PETERSBURG HARBOR REHABILITATION

PROJECT No. 69719

AS BUILT

69719
PETERSBURG
NORTH HARBOR
KUPREANOF &
PAPKE LANDING
REPAIRS
Sht 1 of 10

STRINGER & DECKING LAYOUT

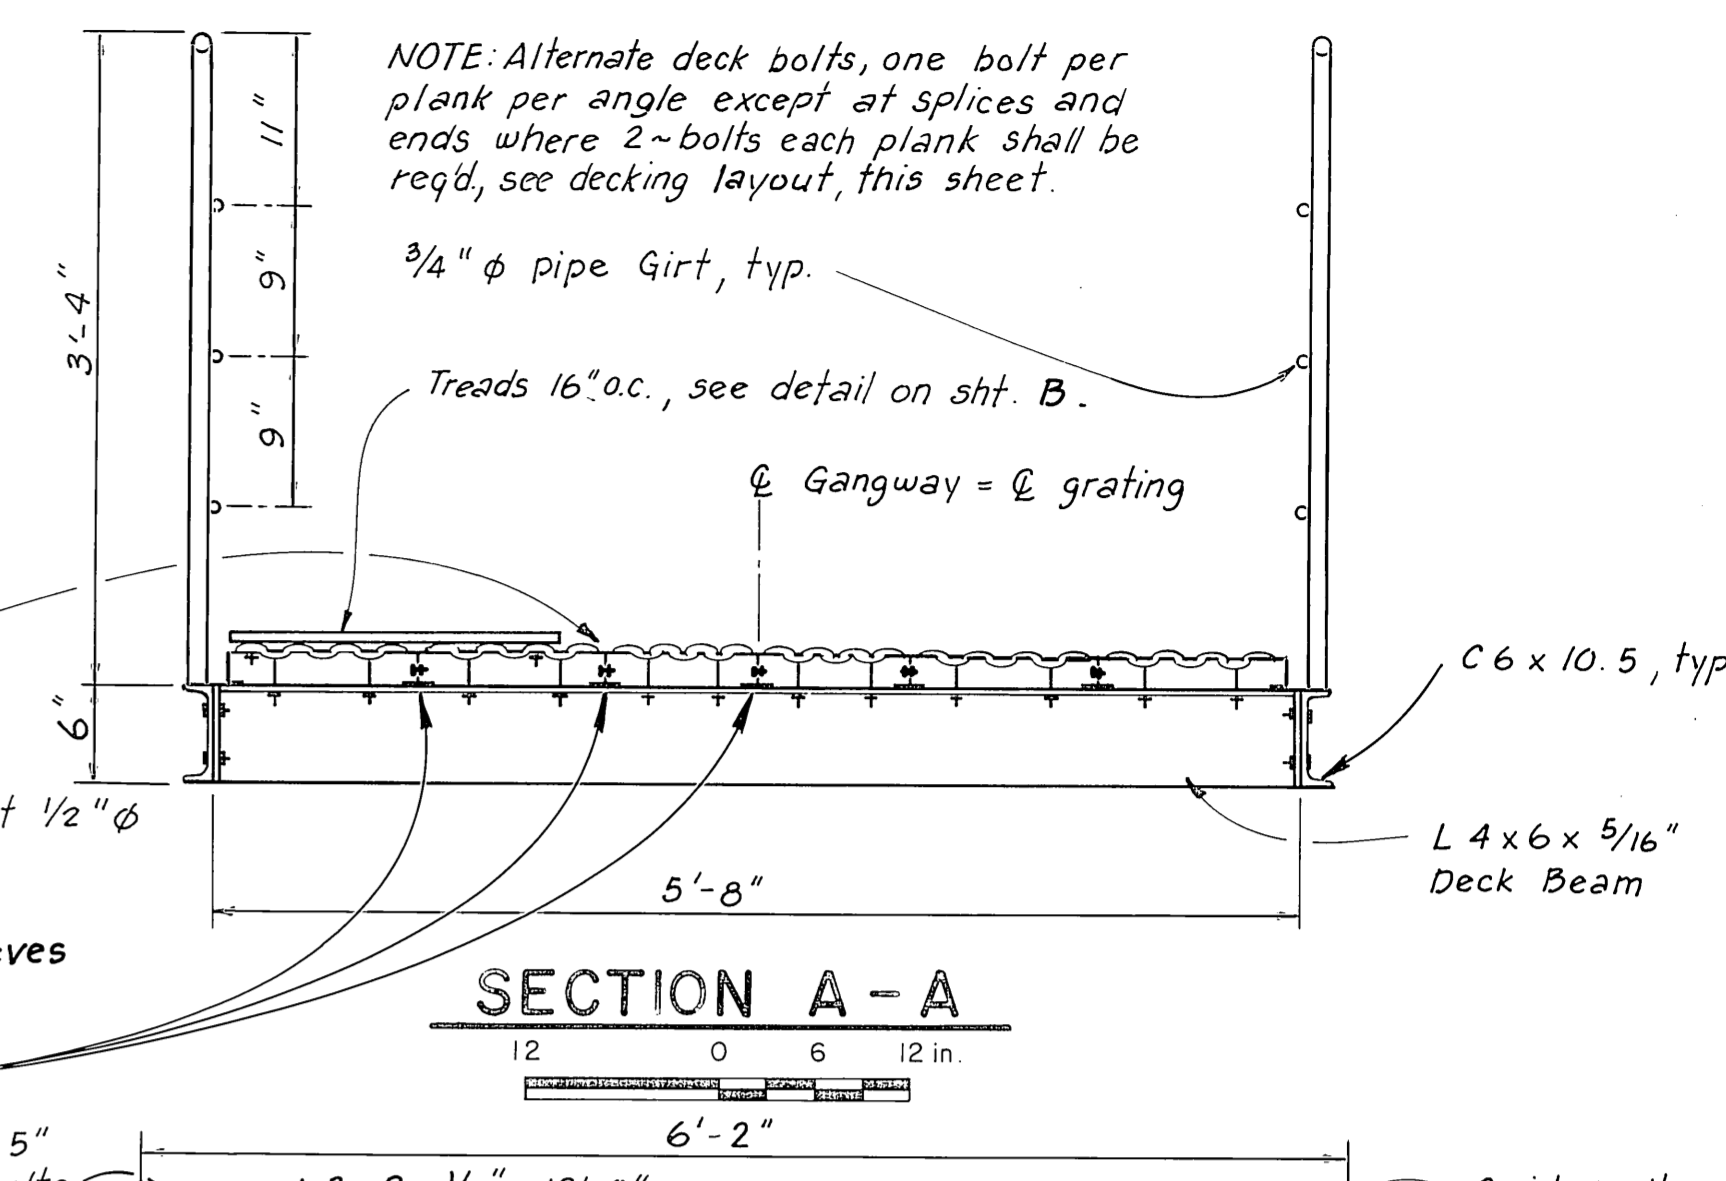
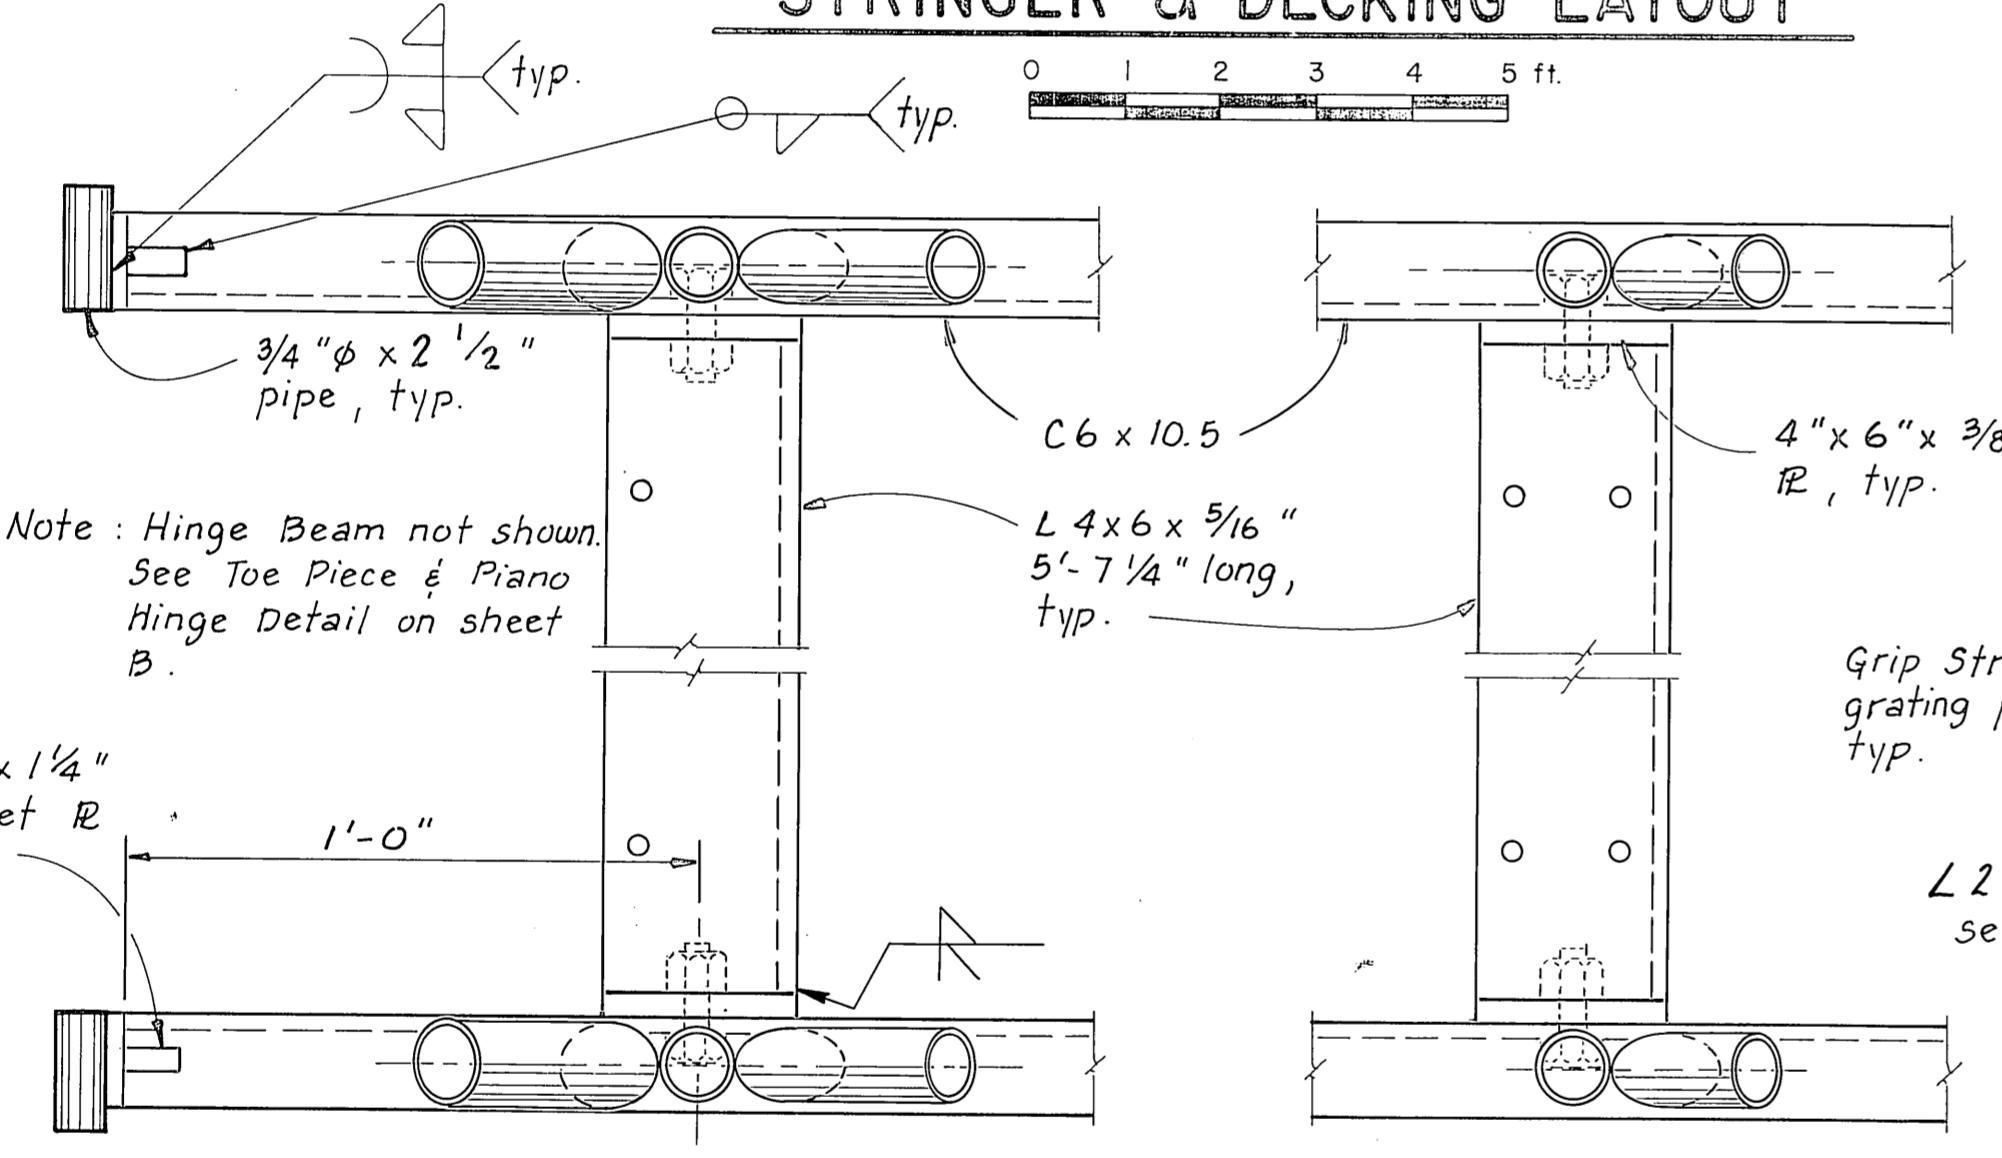
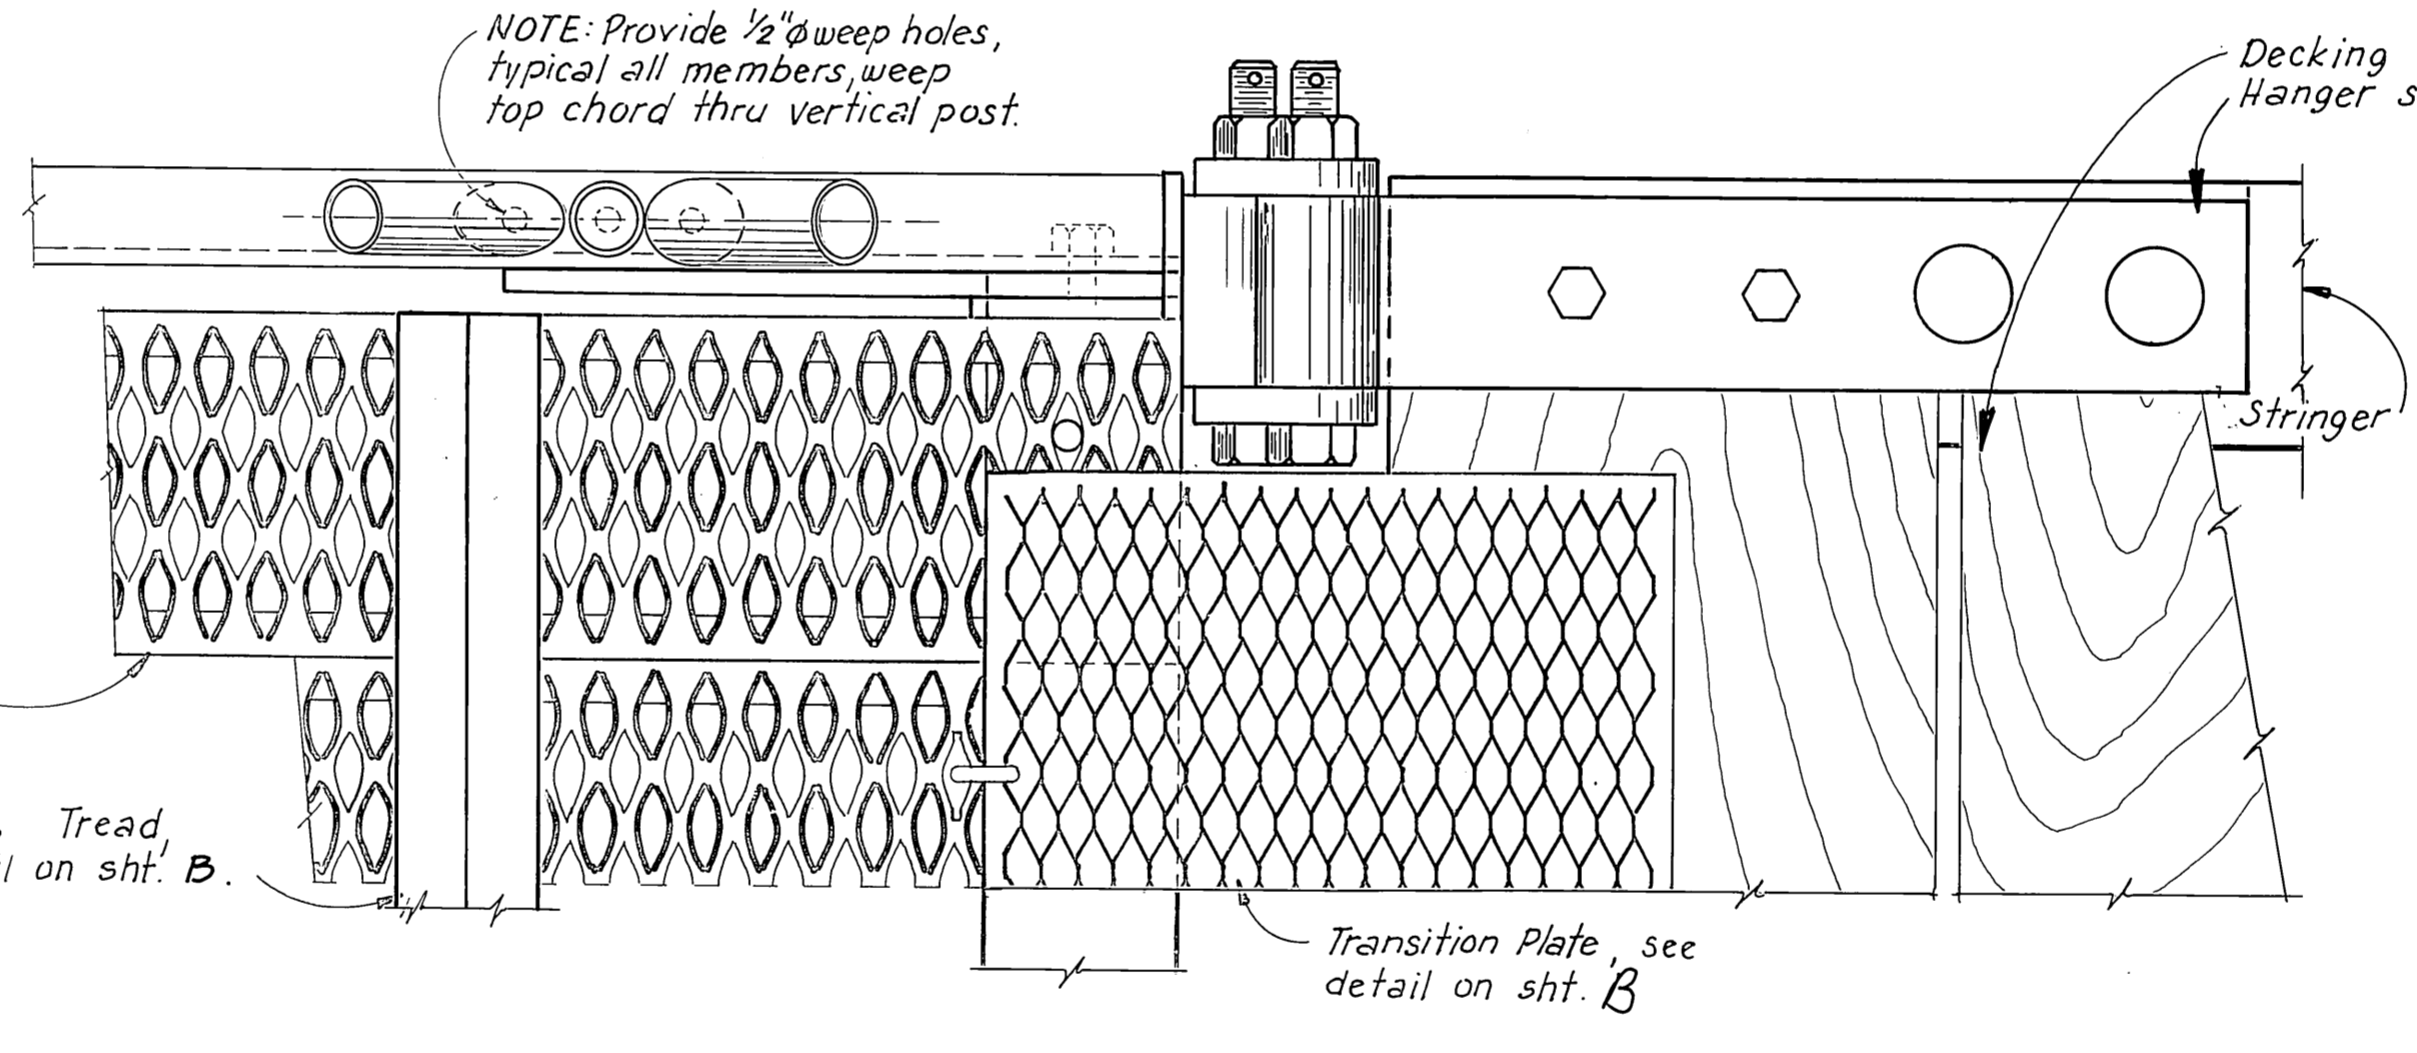
NOTE: Secure grating planks to deck beams w/ diamond anchors & 5/16" φ carriage bolts w/ square shanks & lock nuts. Field cut 1/2" φ sched. 80 6061-T6 or 6063-T6 Alum. pipe sleeves for all carriage bolts at grating plank splices, See detail P. Cut sleeves appropriate length to resist plank deflection and provide a uniform transition between planks. Bolt grating plank channels together every 2'-0" w/ 3/8" φ bolts w/ lock nuts. **Some bolts are S.S. w/ lock nuts, some are galvanized w/ double std. nuts**
